RE: Veterans Affairs National Cemetery Traffic Impact Analysis (G06D001)

Response to City of Albuquerque Comments

DATE: September 10, 2024

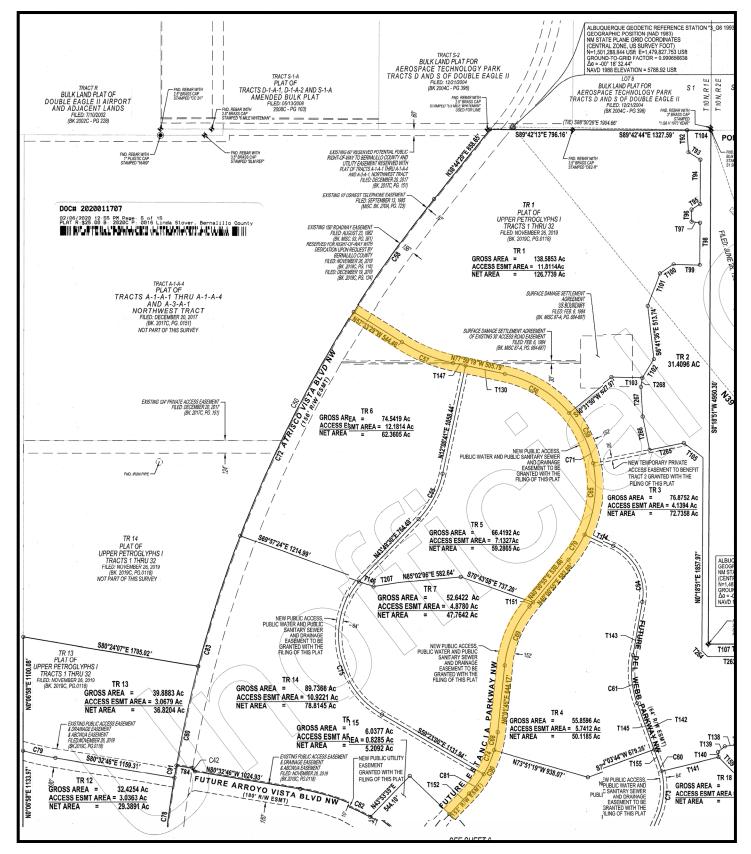
Comment 6: To minimize conflict points, it is preferable to only have one driveway on Shooting Range Road. It appears the location of "Service Entrance" on the Conceptual Site Map is directly across the road from Aerospace Pkwy, which is an acceptable location.

Response 6: The secondary service road on Shooting Range Road is critically important to the long-term and short-term operation of the cemetery for the following reasons:

- The cemetery construction will start with an initial smaller phase to allow the cemetery to open in time to avoid depletion of available burial types to veterans in the greater Albuquerque/Sante Fe region. This first phase will include construction of the paved primary service entrance on Shooting Range Road and installation of temporary trailers to allow the cemetery to begin operations quickly and serve the public and veteran families. The main entrance on Atrisco Vista Road will not be completed prior to this initial phase. Therefore, in order to keep cemetery visitors and staff separate from the on-going construction traffic, the western entrance on Shooting Range will function as the construction entrance.

- After the full cemetery construction is complete and all entrances open, the cemetery needs to maintain the secondary service entrance on Shooting Range Road to keep future construction material deliveries off of the paved cemetery visitor roads to avoid damaging the roadways and to maintain the shrine standards that all national cemeteries strive to achieve and maintain.

- The cemetery operations require outside contractors who are not able to access the VA maintenance yard. The secondary service entrance would provide access for those outside contractors when normal cemetery operations are closed and other entrances are locked.

- The cemetery will expand every 10 to 15 years for the next 100 years. The secondary service entrance on Shooting Range Road will serve as the future construction access to ensure that construction vehicles do not disrupt the cemetery operations when future expansions occur.

There is flexibility to shift the secondary service entrance on Shooting Range Road to the east or the west, if desired; however, for the reasons cited above the access is critical for the operation and on-going development and expansion of the cemetery.
